**REGULAR MEETING OF THE UNITED LAGUNA WOODS MUTUAL
ARCHITECTURAL CONTROL AND STANDARDS COMMITTEE**

**Thursday, December 20, 2018 – 9:30 a.m.
Laguna Woods Village Community Center Sycamore Room
24351 El Toro Road**

DATE: December 20, 2018
FOR: Architectural Control and Standards Committee
SUBJECT: Variance Request: Mr. Randy W. Felten of 58-E (Barcelona, 10B)
Patio Enclosure

RIGHT ELEVATION

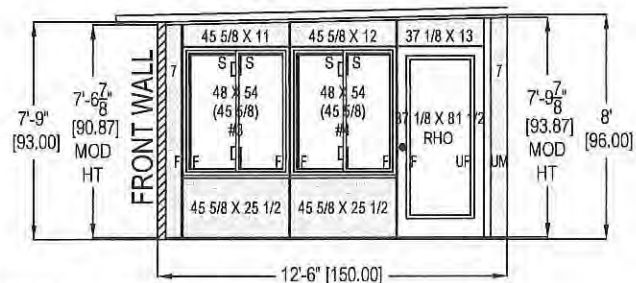
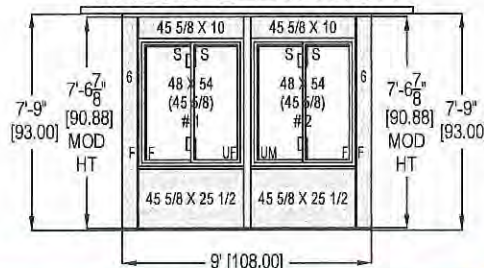
The approved Mutual Standard requires that at least a portion of the wall must remain in place, therefore, by completely removing the block wall, the proposed enclosure doesn't meet Mutual Standards; Board approval is required prior to issuing a Mutual Consent for the alteration.

Mr. Felten proposes to construct a 9' wide by 12'6" long patio enclosure within the existing front patio of the unit. The proposal calls to remove the existing block walls that surround the patio and install a white vinyl framing system with dual pane windows and insulated roof panels to enclose the area. All of the proposed work is within the original footprint of the unit.

The right elevation of the enclosure will consist of a 37" wide by 6'8" tall door, and two 3'8" wide by 4'6" high windows. Panels with a white stucco finish will be used for the transoms and kick plates.

The front elevation will contain two 3'8" wide by 4'6" wide windows with matching simulated stucco panels.

The proposed roof will have ¼" per foot slope, an integral gutter and downspouts, and will be tied in at the existing 7'9" roof height. Insulated panels will be used along with a beam to allow an interior ceiling fan to be installed.

2. A Variance for Alterations has been granted at **58-E** for **Enclosure on front Patio**, subject to the attached plans stamped approved and is subject to a final inspection by the Division. Any variations to the approved attached plans are not allowed and could result in a stop work notice and/or severe fines to the Shareholder.

FLOOR PLAN

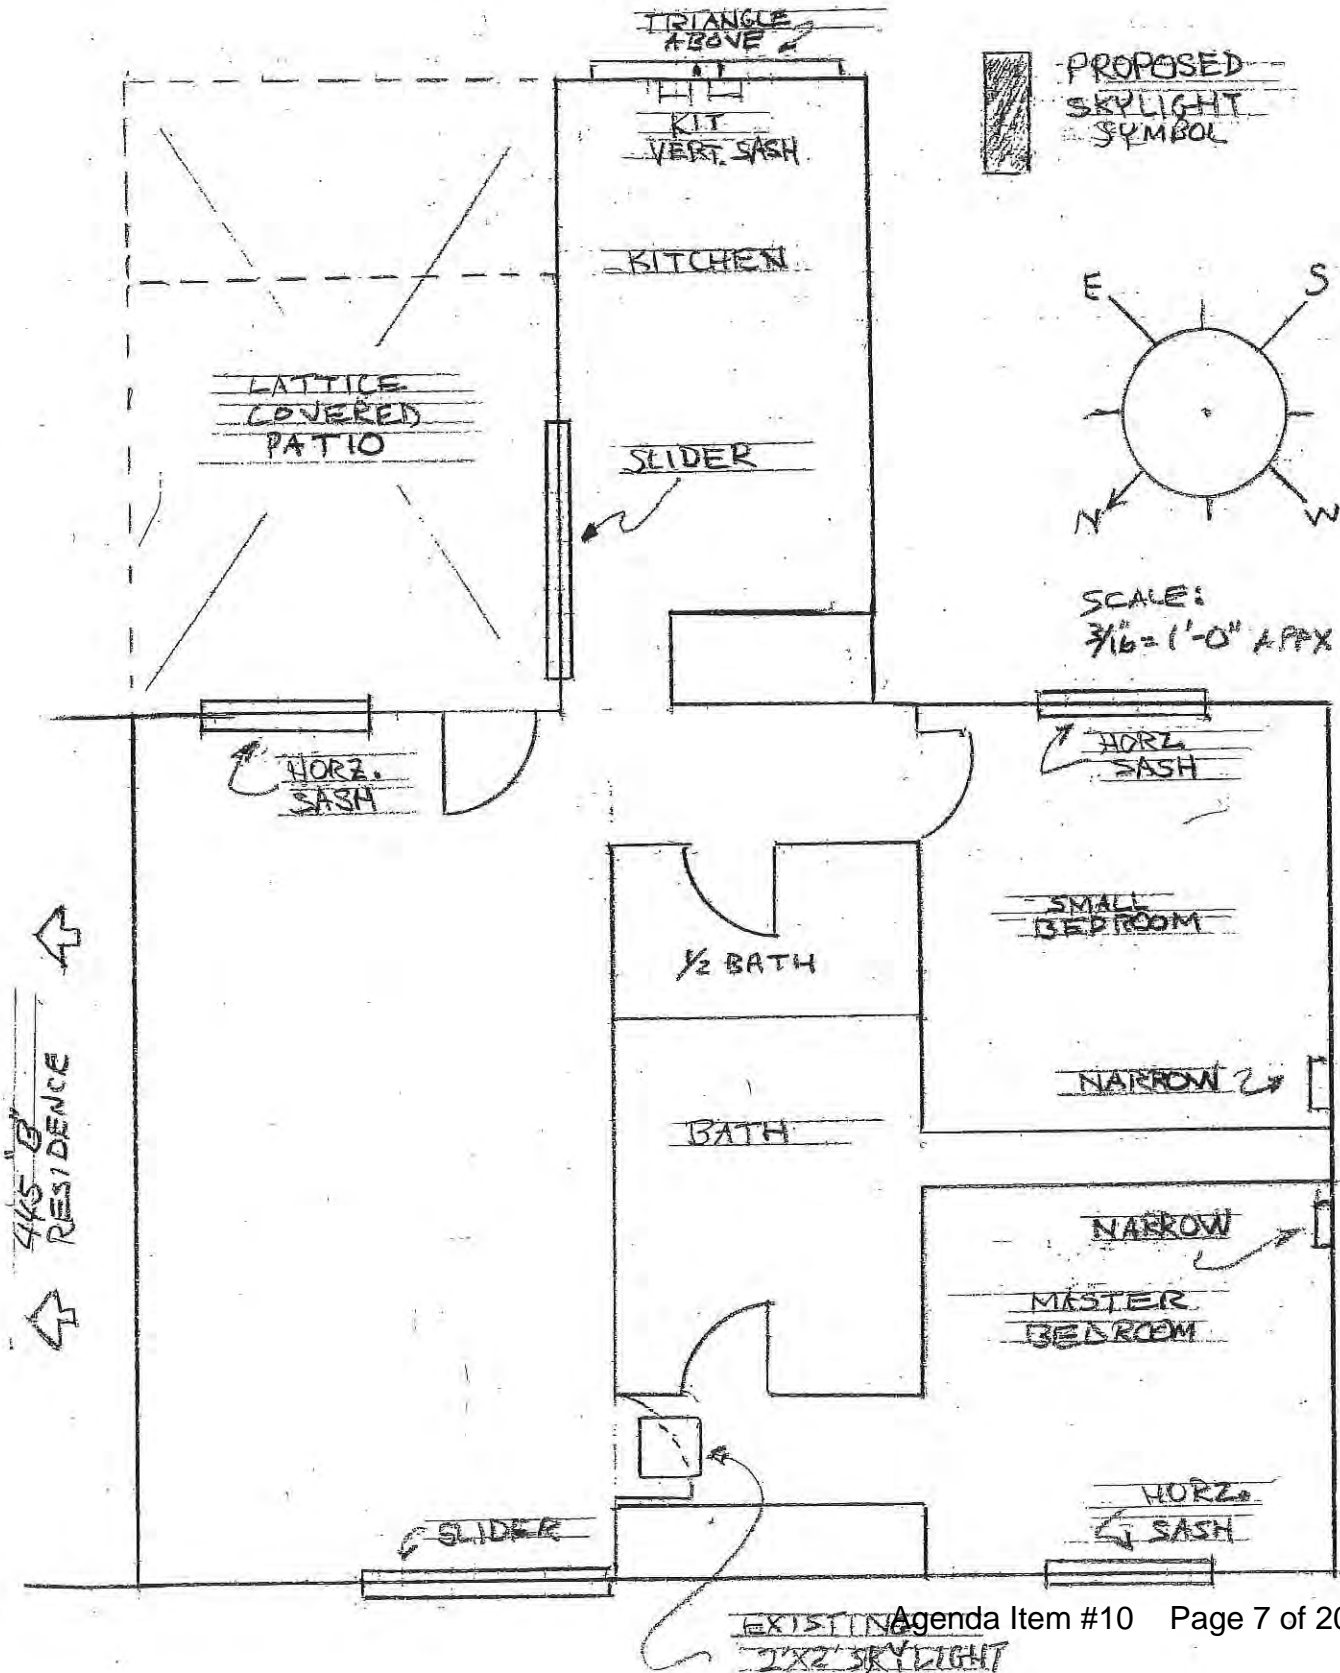
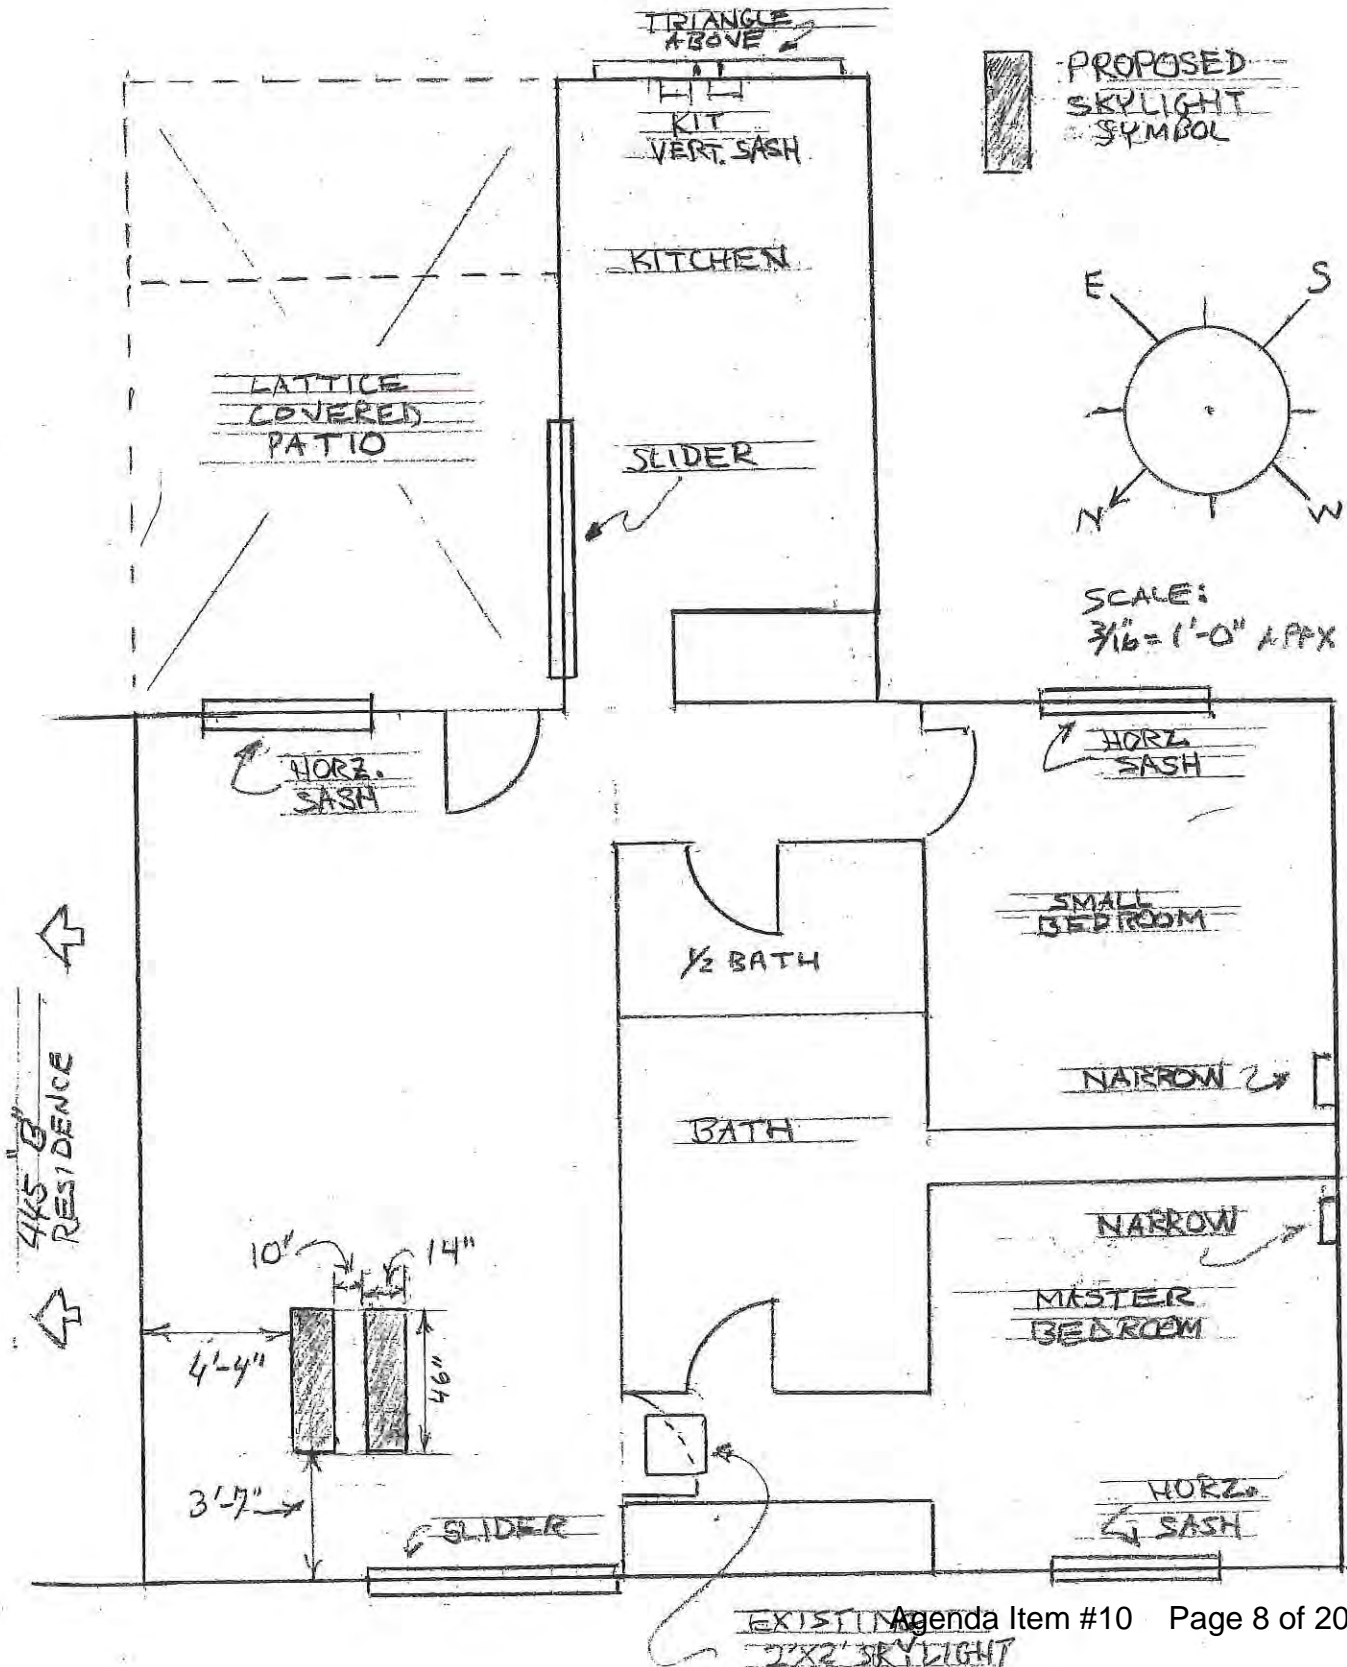
There is an existing 2’ wide by 2’ long, white domed skylight located in the master bedroom of the unit. As stated above, §2.6 of the Mutual Standards for skylights requires consistency with all skylights within a unit. Staff recommends approval of the variance request, with an added condition that the existing skylight is modified to have a consistent flat glass finish to match the proposed skylights (see Appendix A).

1. Existing skylights to unit 455-A are required to be modified so as to match the design of the new skylights as approved by the Board
2. No improvement shall be installed, constructed, modified or altered at Unit **455-A**, ("Property") within the United Laguna Woods Mutual ("Mutual") without an approved Mutual Consent for Alterations application for the improvement has been made to, and approved, in writing, by, the Village Management Services, Inc. ("VMS, Inc."), Alterations Division ("Division"), or, in the event of a Variance from the Mutual's Alteration Standards, the Architectural Control and Standards Committee ("ACSC"). In the event written permission is given for the installation, construction, modification or alteration of any improvement(s) upon the Property, the Shareholder s ("Shareholder ") agrees to comply with the Mutual's Governing Documents and any specific terms or conditions imposed, and that the installation, construction, modification or alteration shall be in strict compliance with the terms of the approval.
